Mitigation Plan

Mushroom Meadow Mitigation Site

Caswell County, North Carolina
Roanoke River Basin HUC 03010104
DMS Project ID No. 100192
Full Delivery Contract No. 200204-01
USACE Action ID No. SAW-2021-00348
NCDWR No. 20210400, V1

Subject: Mitigation Plan
Mushroom Meadow Mitigation Project, Caswell County
Roanoke River Basin HUC 03010104
USACE Action ID SAW-2021-00348/NCDWR 20210400, V1

PSH-02.2.3
SHEET

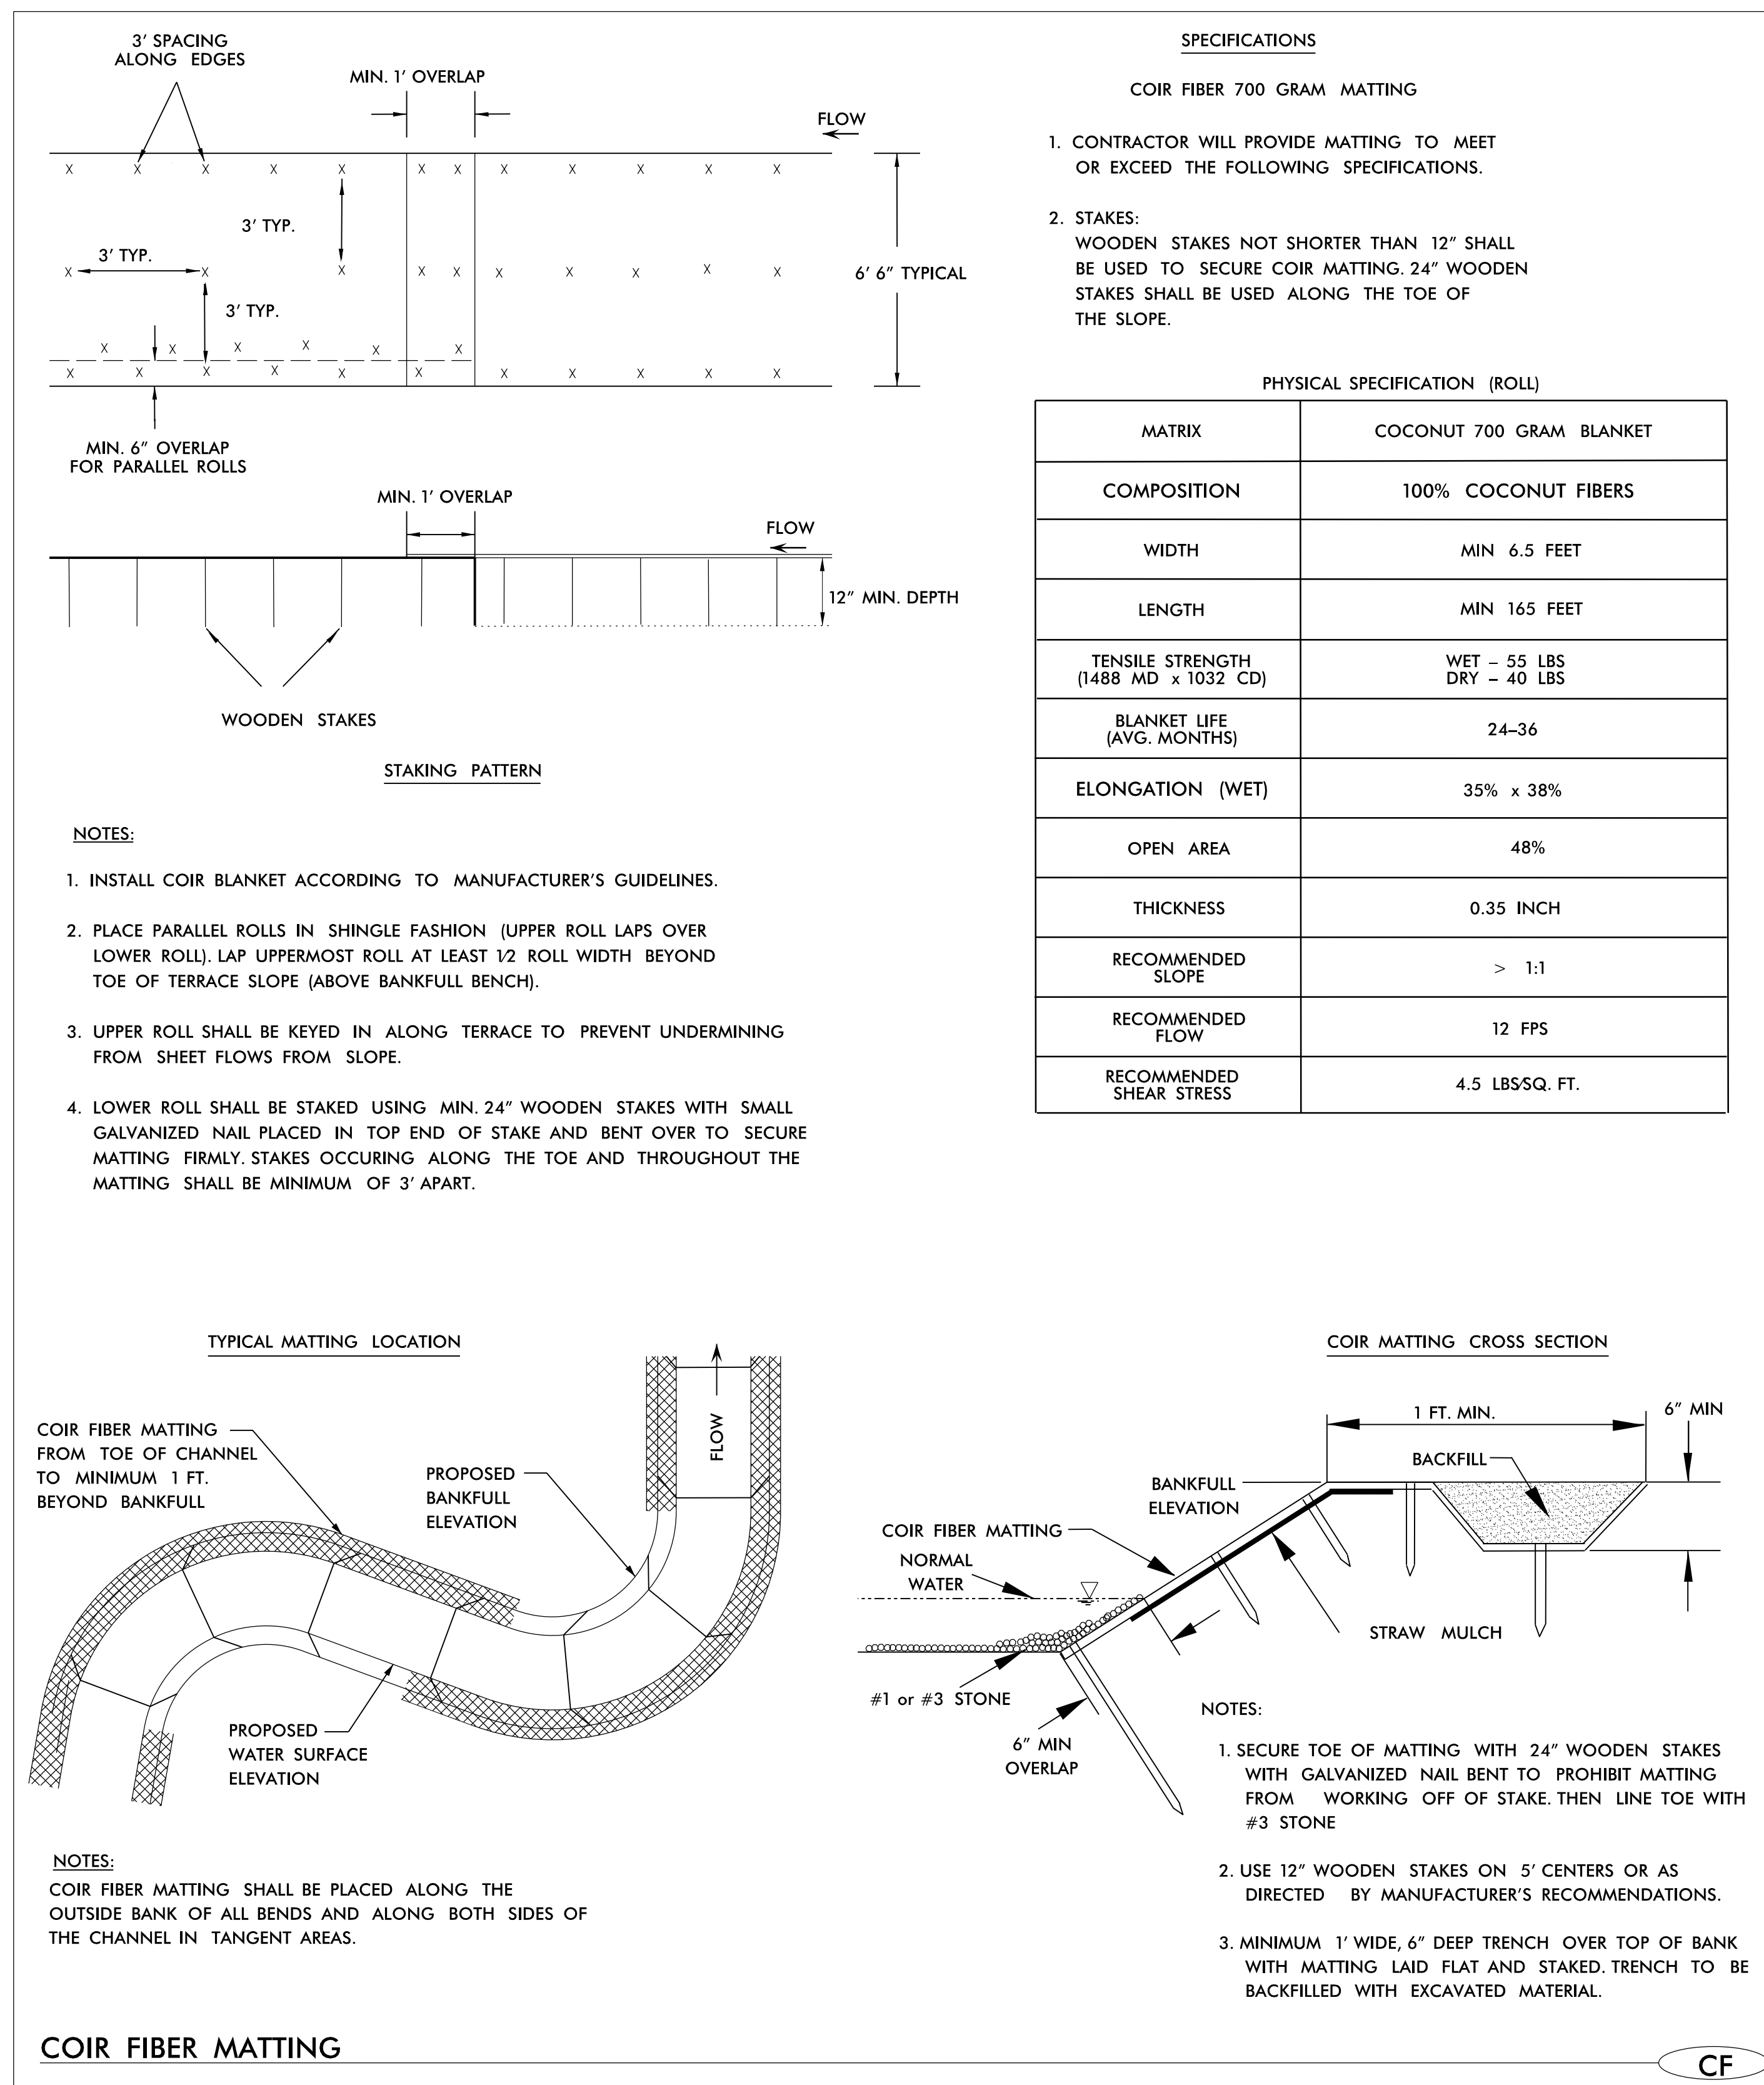
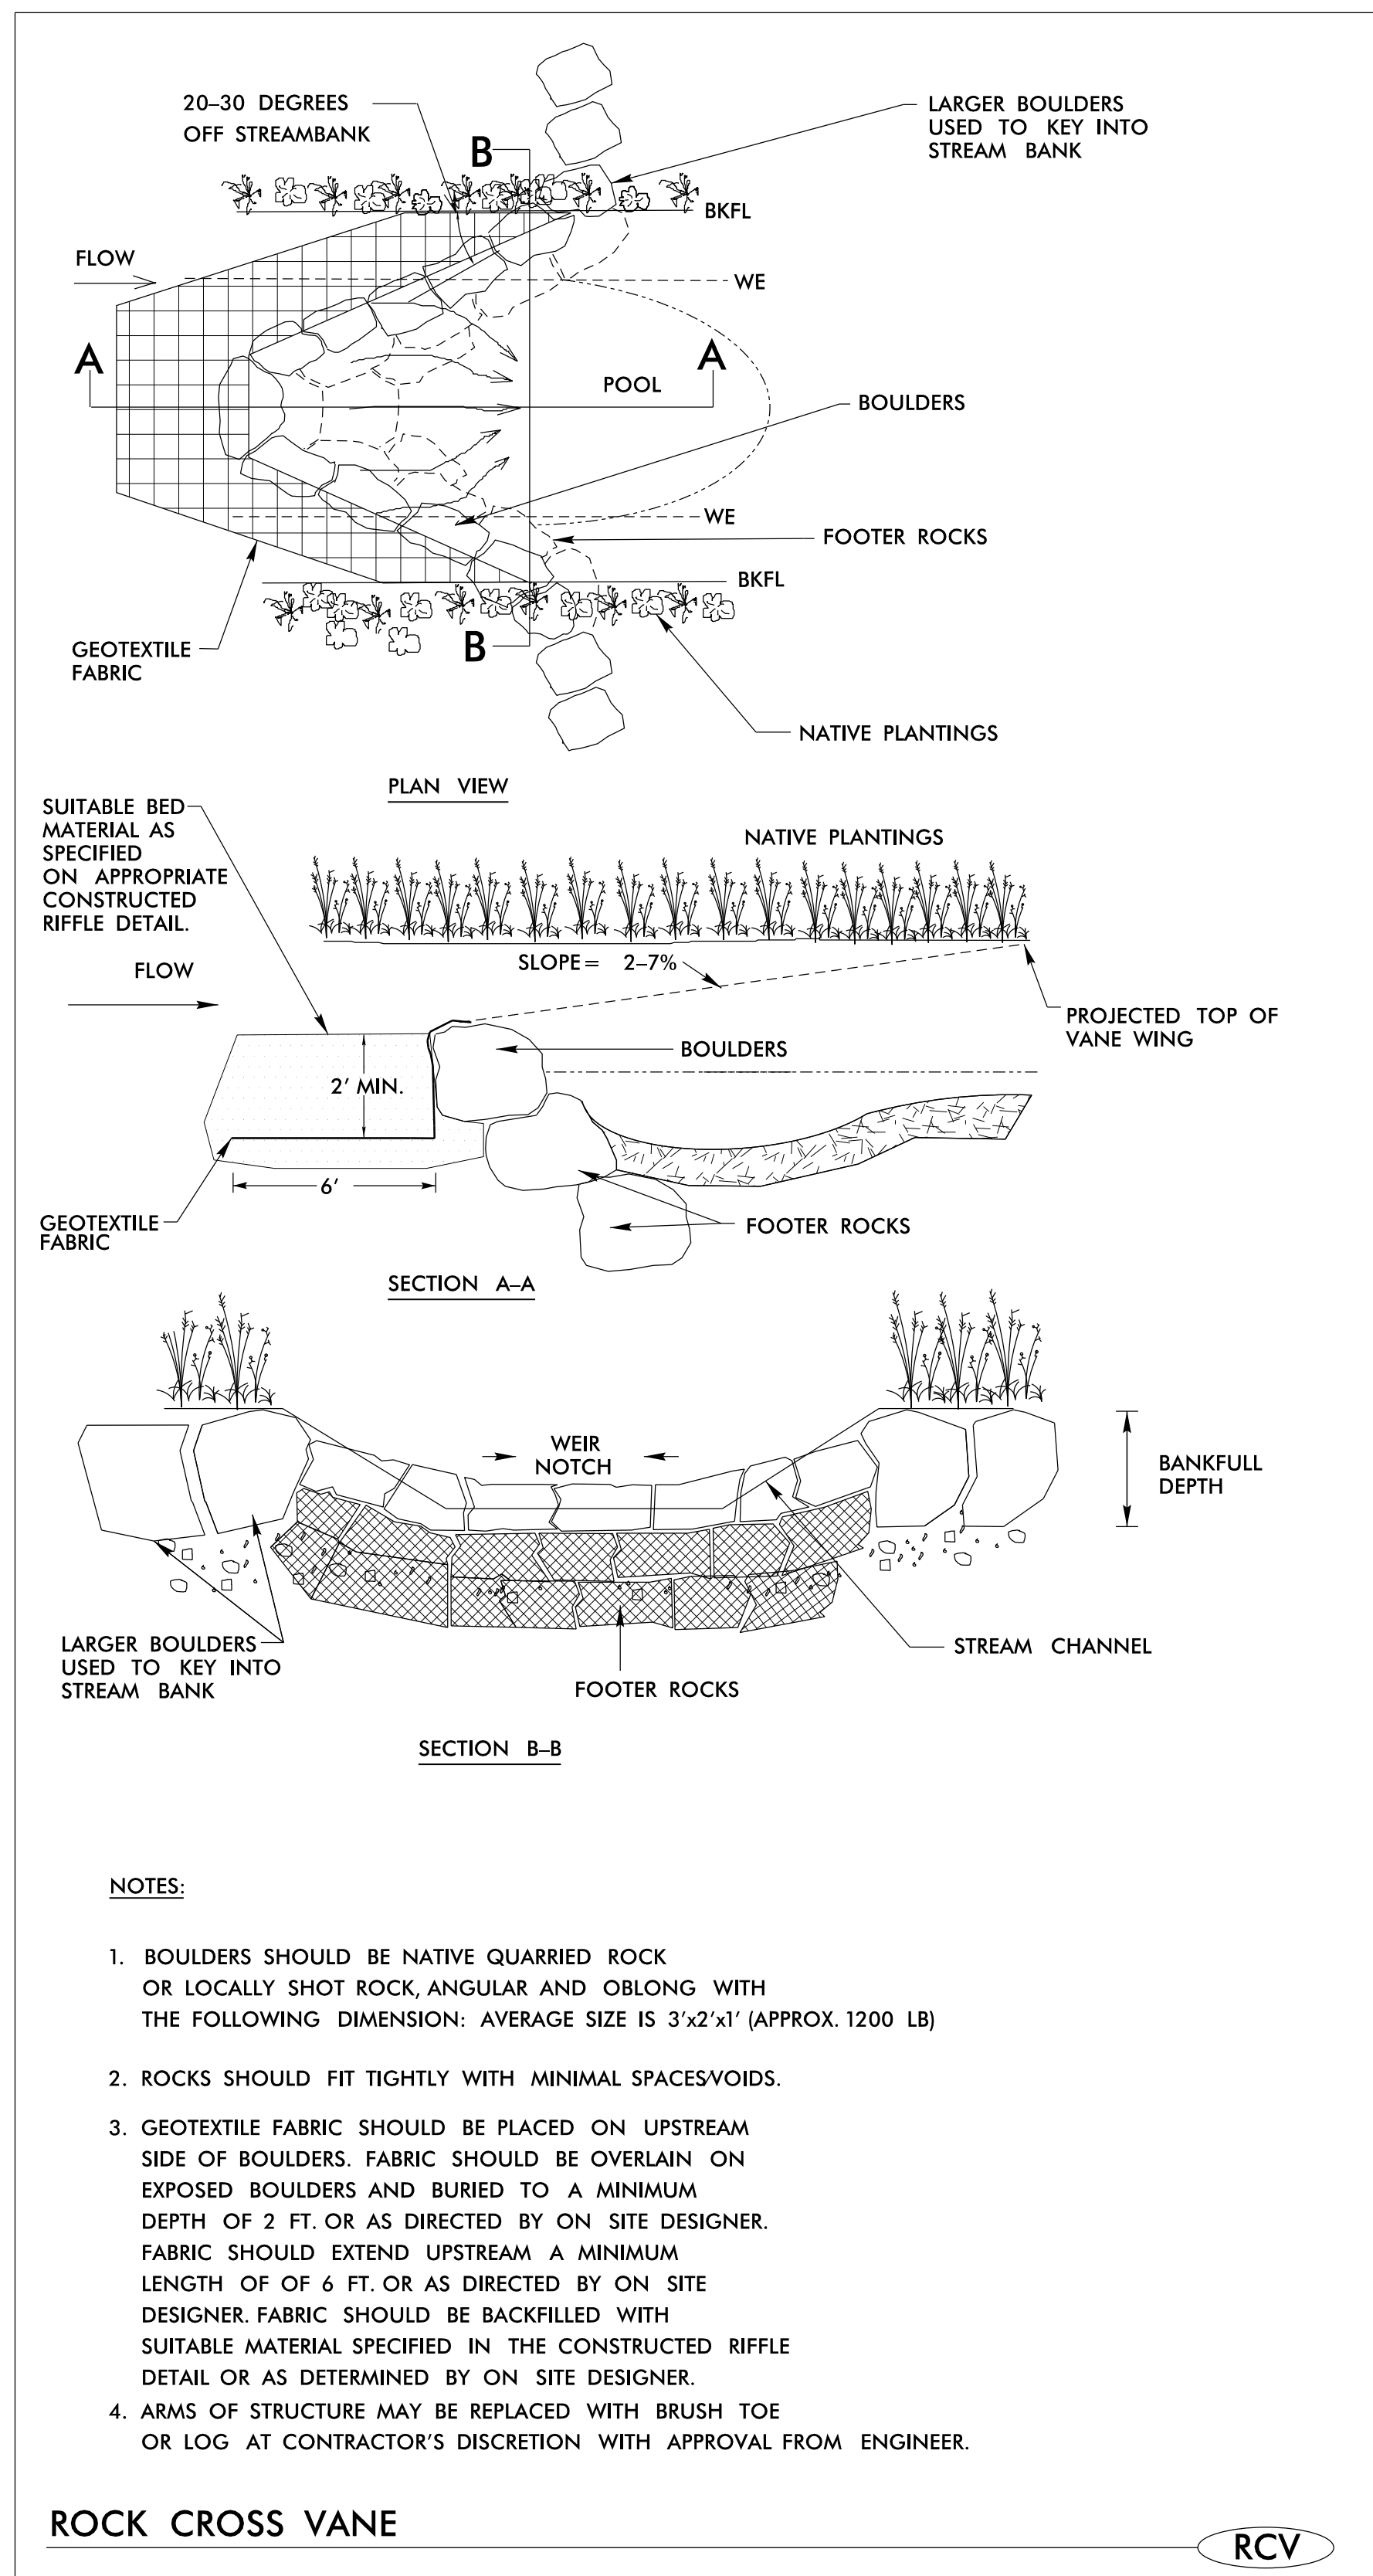
27. Sheet PSH-02.2.3 Floodplain Depression – Based on the proposed 3-foot depth, DWR would anticipate these depressions to become open water areas. However, these areas are included in the proposed planting plan. What is the expected tree coverage within these areas? Generally, DWR encourages shallower depressions that seasonally dry for better vegetation establishment and wildlife habitat. Also, please confirm these features are not proposed to have outlets structures/paths. If outlets are proposed, please include details on material and dimensions, and show on plan view sheets. **These features are being shown with a maximum depth of 3-feet and are used to help balance the cut/fill across the site. They are not designed as a specific wildlife habitat and it is expected that they will fill with sediment over time as there is no outlet proposed. Wetter species from the wetland zone will be planted in these areas and it is anticipated that they may be colonized by the obligate species on-site, *Salix nigra*, *Salix sericea*, or *Cephalanthus occidentalis*.**
